**FINAL PROOF SURVEY**  
UNDER

R-47599                      R-5734  
Application No. 47600... Permit No. 35629:..  
IN NAME OF

Proof of Appropriation of Water

**Abstract of Permit No. R-5734**

T. 38 S. R. 5 W.

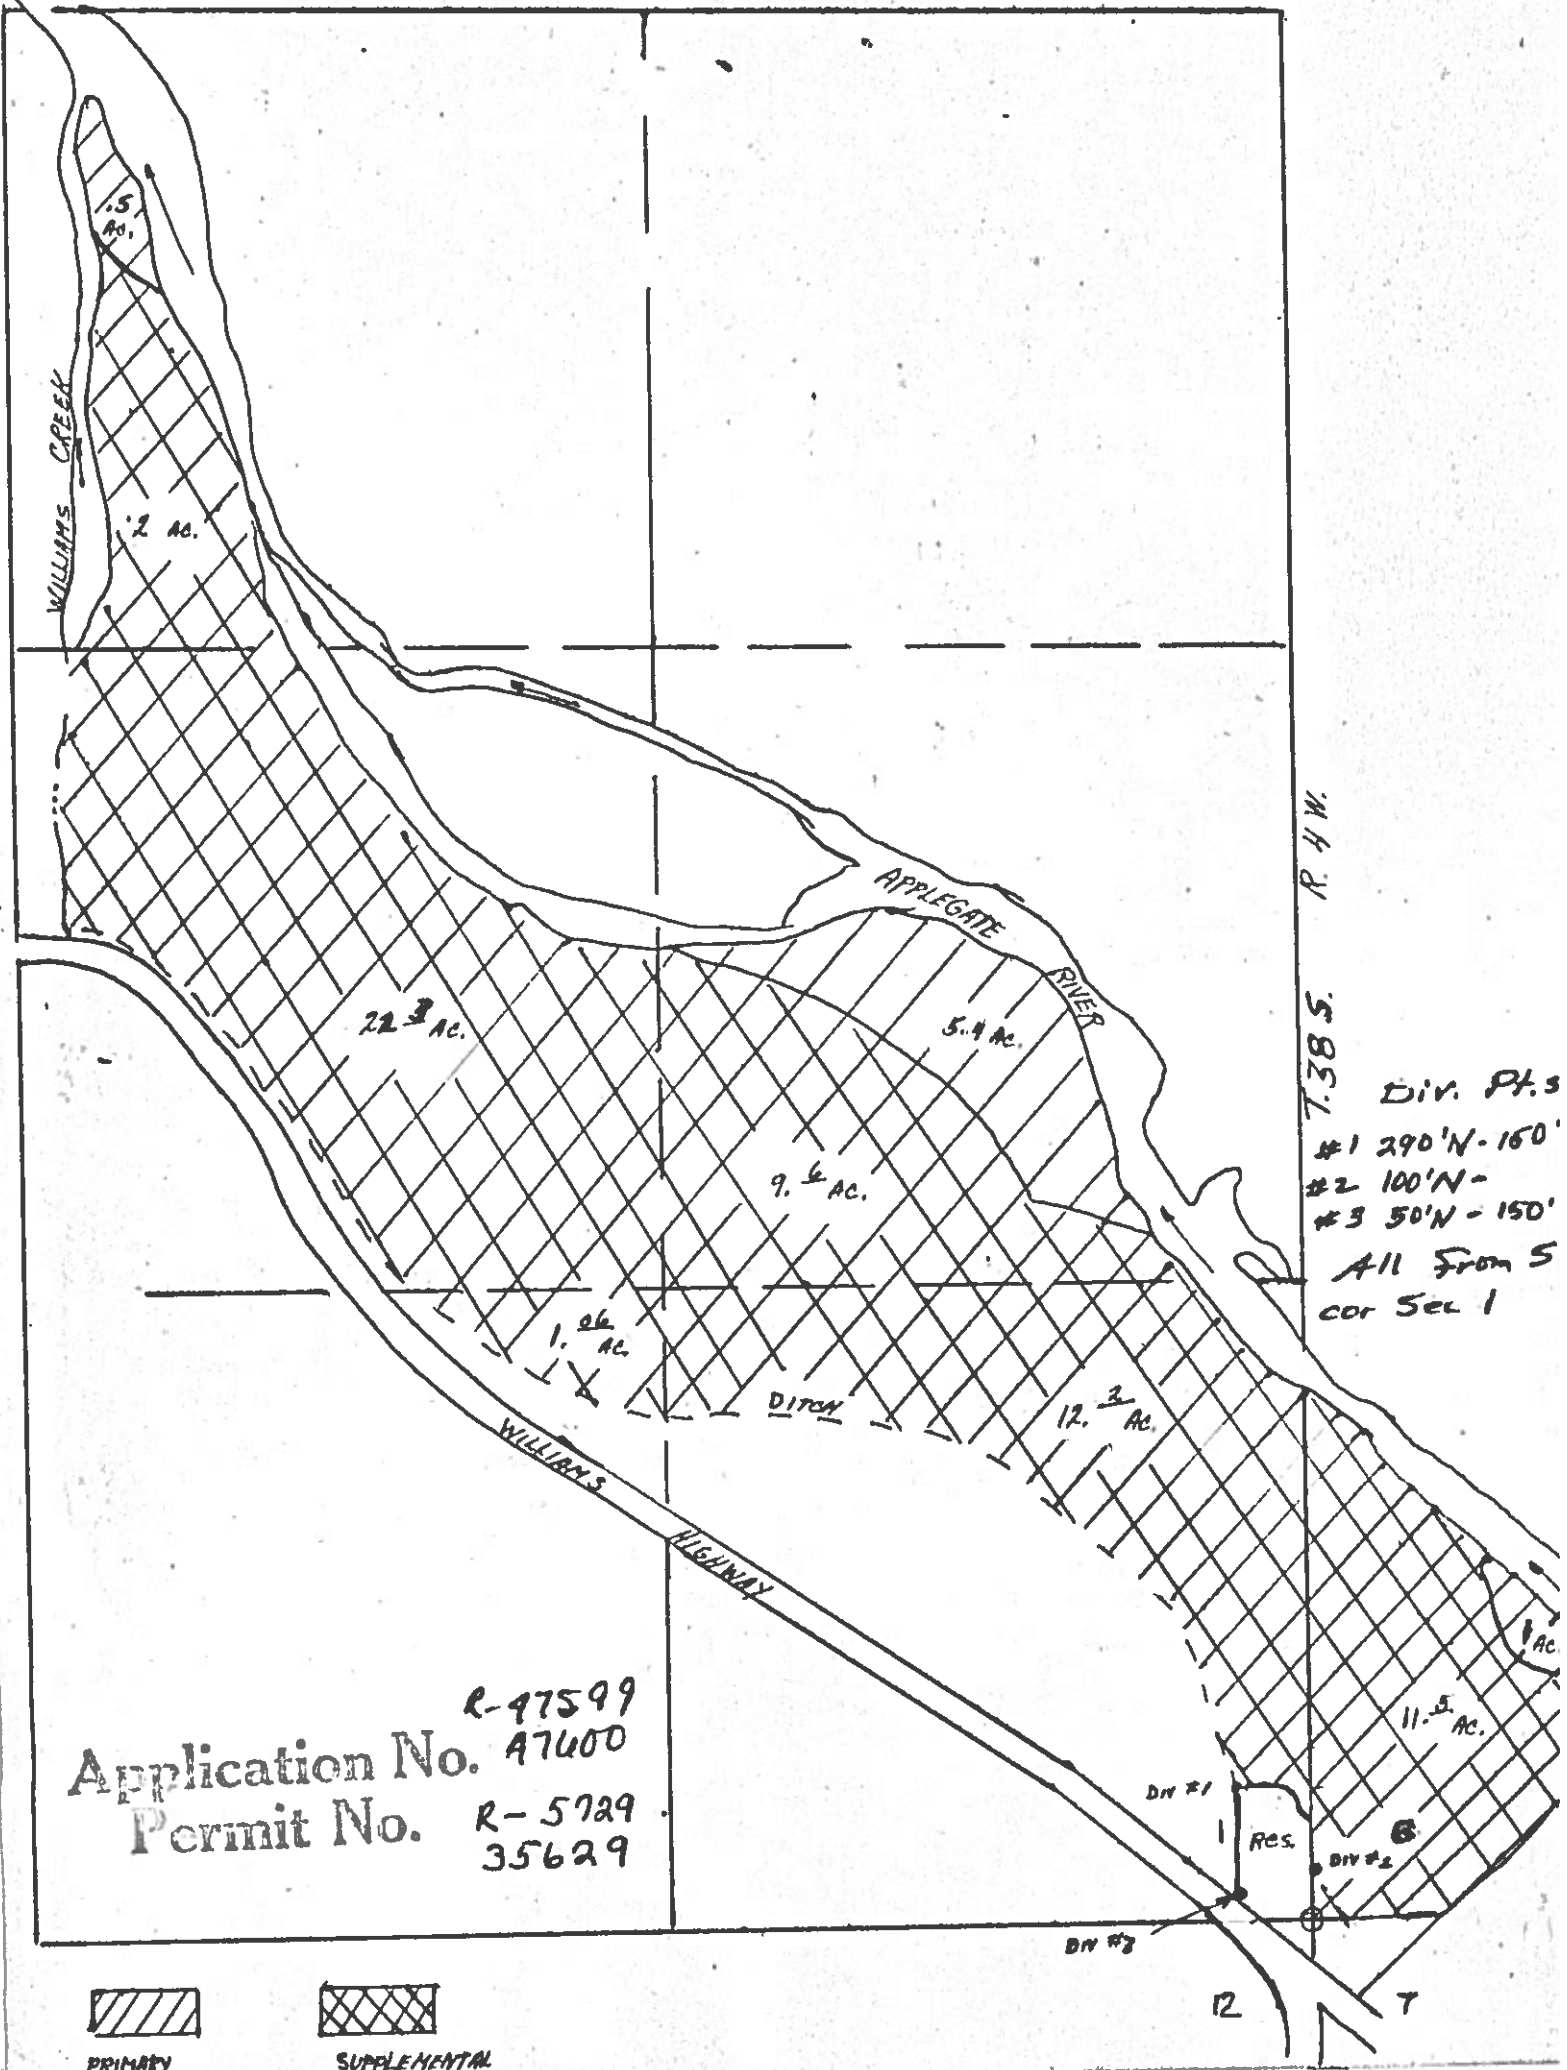
Item No. 10 on the reservoir application indicates a surface area of one acre. From the dimensions shown on your map, the surface area appears to be between two and one half and three acres. Assuming

the dimensions on the map are correct and the mean depth of 4.5 feet as designated in item No. 10, the reservoir will store from 11.25 to 13.5 acre feet of water. Will you please recheck the dimensions shown on the map and the capacity computations and correct whichever is in error.

Enclosed is a copy of the map made in connection with the inchoate proceedings of the Rogue River Adjudication. The area hatched in black is the land irrigated under the right evidenced by certificate 32813. The area outlined in green is that to be irrigated from your reservoir. The area shaded in solid green is the land that does not have an an existing right on it.

The location of the 9.6 acres of supplemental irrigation in the NE $\frac{1}{4}$  NE $\frac{1}{4}$  of Section 1 does not agree with that shown on the inchoate map. Certificate 32813 describes the irrigation of 22.3 acres in the NW $\frac{1}{4}$  SE $\frac{1}{4}$  of Section 1. Your map includes all of the land shown under the earlier right but designates it as being only 21.5 acres. The entire 1.06 acres in the SW $\frac{1}{4}$  SE $\frac{1}{4}$  is included in the earlier right. Certificate 32813 described the irrigation of 11.5 acres in the SW $\frac{1}{4}$  S $\frac{1}{4}$  of Section 6. Your application describes the primary irrigation of 12.5 acres in this forty. Much of the land described in your application is included in the earlier right.

Application No. 47600 and the map must be in agreement with the earlier right as to the location and number of acres of supplemental irrigation.

**EARTH DAM:**

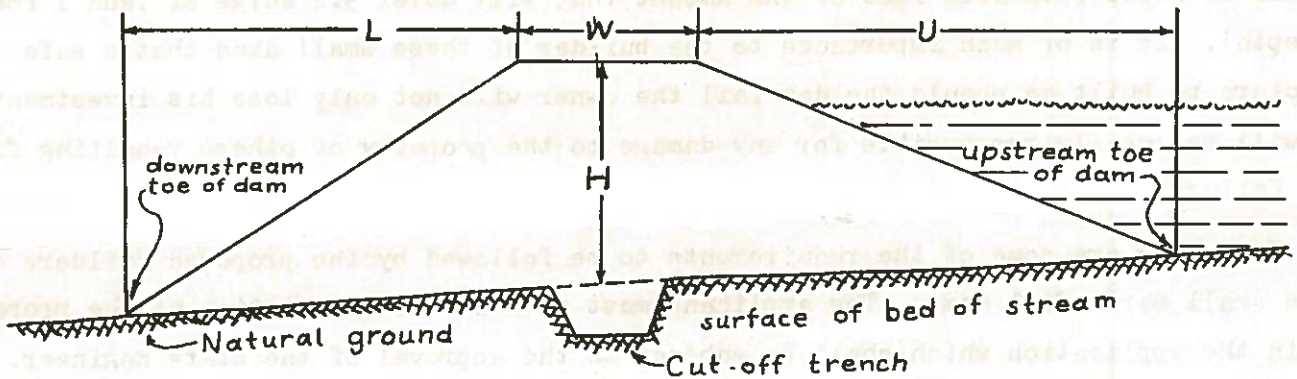
The small dam data sheet has been completed to describe the spillway as being a 24 inch pipe with the bottom of the pipe 4 feet from the top of the dam. Item No. 6 on the reservoir application indicates the height of dam above high water line when full is 2.5 feet. These two entries should be in agreement designating the distance from the bottom of the culvert to the top of the dam. Item No. 8 on the reservoir application must also give this dimension to the bottom of the 24 inch pipe.

The small dam data sheet must be completed to designate the distance between the top of the dam and the bottom of the spillway or over-flow pipe.

Item No. 8 on the reservoir application describes the waste way as being an 18 inch concrete pipe through the base of the dam. Item No. 9 indicates that 24 inch pipe at the top as over-flow. Item No. 8 should be corrected to describe the over-flow pipe.

The small dam data sheet designates the depth of spillway as being six feet. Item No. 6 on the reservoir application indicates the height of dam above high water line when full as 2.5 feet. Item No. 8 describes the waste way as being an 18 inch steel pipe through the base of the dam. These three entries should be in agreement.

Item No. 9 on the reservoir application should describe the outlet through the base of the dam. If there is no spillway, is the inflow to the reservoir controlled? If so, please describe the method of control in the section provided for remarks.

The small dam data sheet should be further completed to designate the number of acres of drainage area above the dam contributing to the waste water flow.

Distance between top of dam and bottom of spillway at the upper end, indicated on sketch by letter "H" is 4 foot feet.  
(Must be at least 2 1/2 feet)

Size and type of outlet pipe through base of dam which will allow free passage of the natural flow of the stream 18".
